Rebuttal Proof of Evidence

Land off Pump Lane, Rainham

APP/A2280/W/20/3259868

Prepared For: Medway Council

Figure 1 Local Validation Data for Subnetwork 2

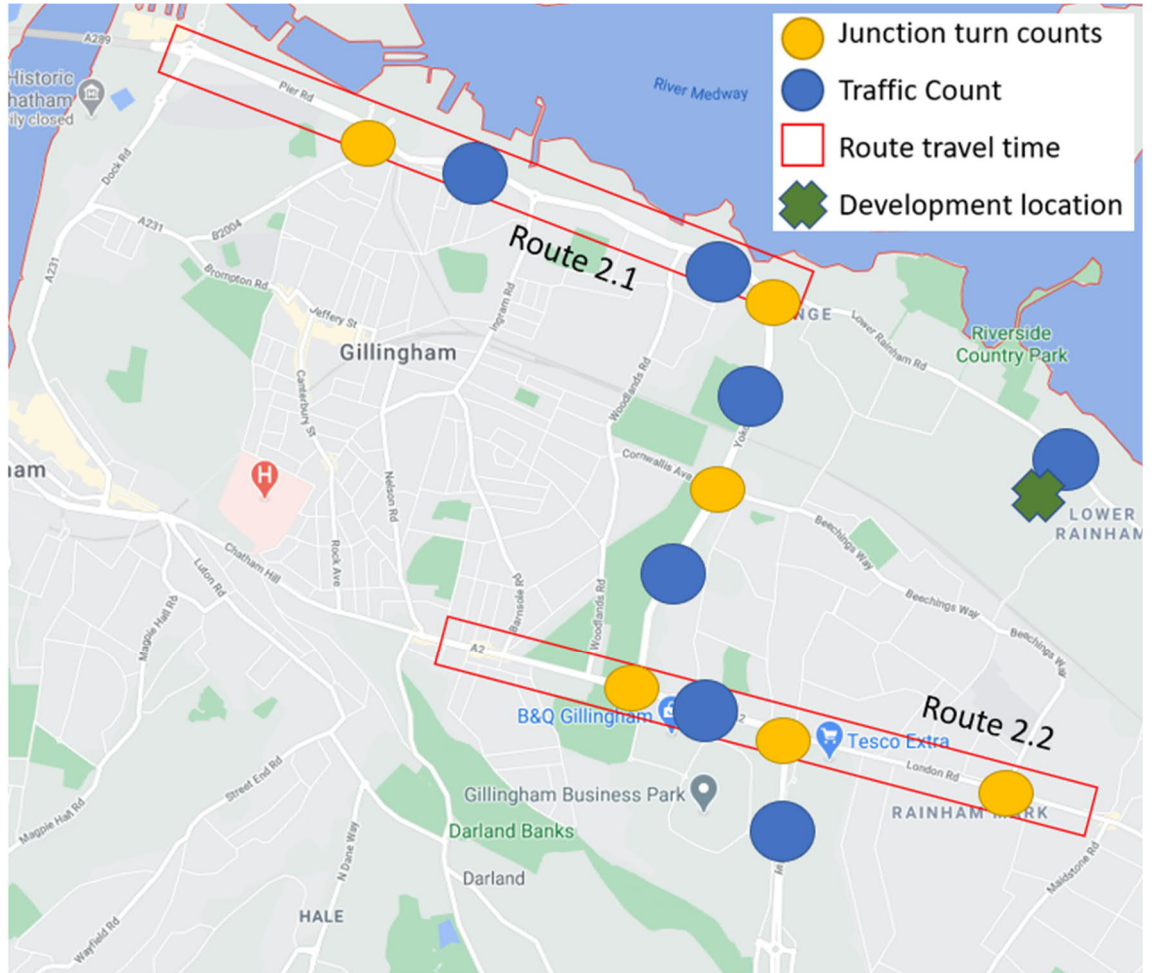
2.9 **Figure 1** shows the 13 observed local link/turn counts and journey time routes used for the local validation check on subnetwork 2 close to the proposed development and on the impacted congested corridors. In addition, 2 journey time routes were used to check local validation on the A2 and the A289 which are the two most congested corridors which are impacted by the proposed development. All this information was derived from the MAM Validation report (CD12.5). **Table 1** (below) provides the flow validation which shows between 96% and 100% of links and turns pass the Department for Transport (DfT) validation criteria for both modelled periods: far greater than the requisite 85%. **Table 2** shows the journey time validation; all local journey time routes pass the DfT criteria of modelled times being within 15% or 1 minute of the observed times.

Figure 2 Local Validation Data for Subnetwork 3

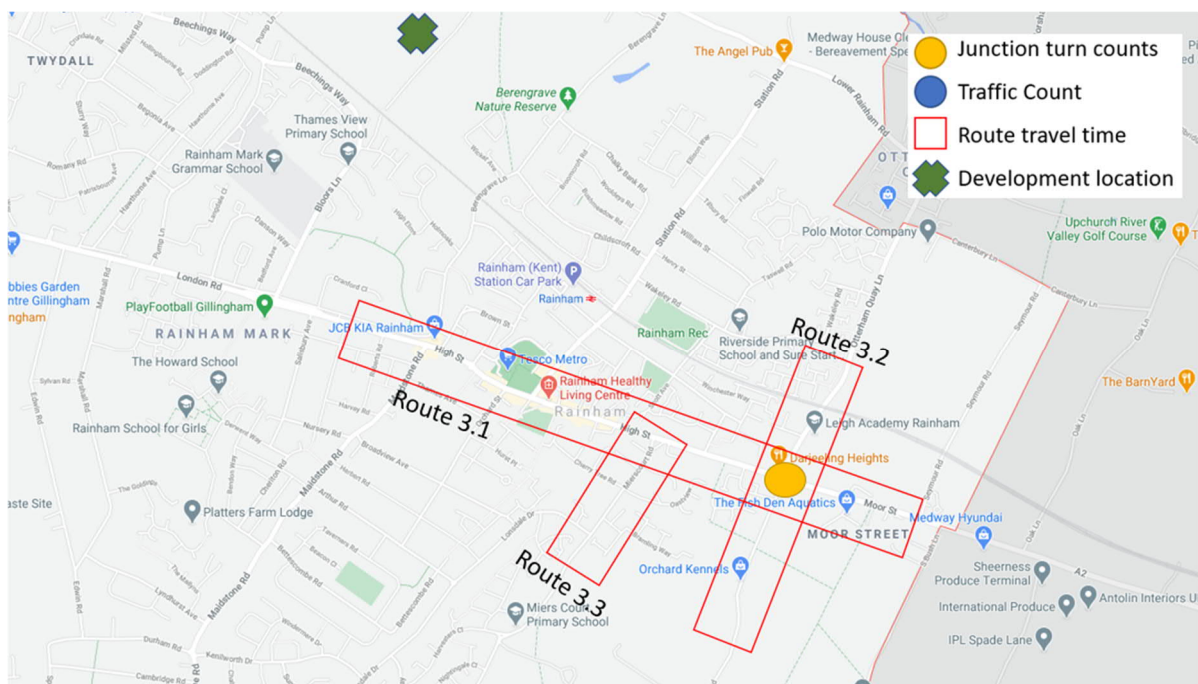
2.10 **Figure 2** shows 1 turn count (12 observed movements) at the key junction of the A2 and Otterham Quay Lane and 3 local journey time routes used as part of the local validation check focussed on subnetwork 3 in Rainham, in the vicinity of the proposed development and on the impacted local roads. The 3 journey time routes were used to check local validation on the A2 in Rainham, as well as Otterham Quay Lane/Meresborough Road and on Miercourt Road. All this information was derived from the MAM Validation report. **Table 3 Local Flow Validation for Subnetwork 3** Table 3 provides the flow validation which shows between 97% and 100% of links and turns pass the DfT validation criteria for both modelled periods: far greater than the requisite 85%. **Table 4** shows the journey time validation; 100% of local journey time routes pass the DfT criteria of modelled times being within 15% or 1 minute of the observed times: again, far exceeding the required threshold of 85% of routes.

Figure 3 Local Validation Data for Subnetwork 7

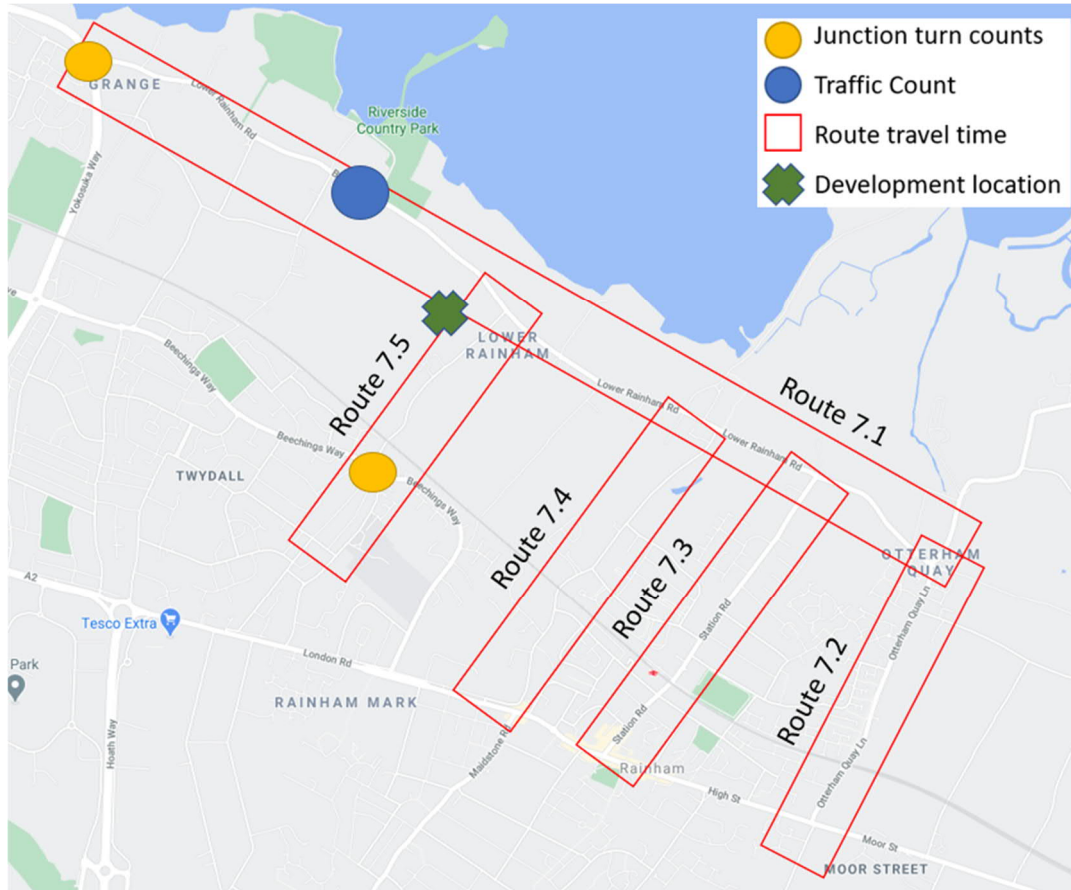
2.11 **Figure 3** shows 3 link/turn counts and 5 local journey time routes used as part of the local validation check focussed on subnetwork 7 in Lower Rainham, in the vicinity of the proposed development and on the impacted local roads. The 3 journey time routes were used to check local validation on Lower Rainham Road and roads off it. All this information was derived from the MAM Validation report. **Table 3 Local Flow Validation for Subnetwork 3 Table 5** provides the flow validation which shows between 97.5% and 100% of links and turns pass the DfT validation criteria for both modelled periods: far greater than the requisite 85%. **Table 6** shows the journey time validation; 100% of local journey time routes pass the DfT criteria of modelled times being within 15% or 1 minute of the observed times: again, far exceeding the required threshold of 85% of routes.
